INITIAL FIRE SAFETY INSPECTION REPORT

AB Mart Fashion Wear Ltd. (Extension)

RSC ID: 26157

Date: 16-Jul-2025

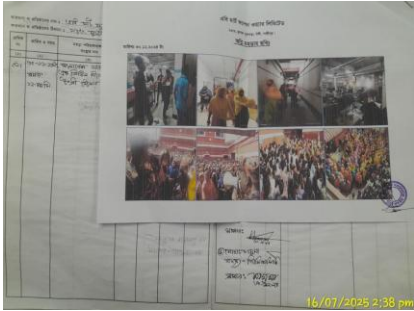
F-10	Means of Egress	A single means of exit has been provided in the 6-storied building. Location: Building-C.	The number of means of egress from any floor, story, or portion thereof shall not be less than 2 except where a single exit is permitted by RSC Technical Guideline (Standard), section 6.6.2. Provide additional exit and ensure that the exit doors or means of egress openings are located a distance apart as per RSC Technical Guideline (Standard) section 6.6.6	Within 3 months
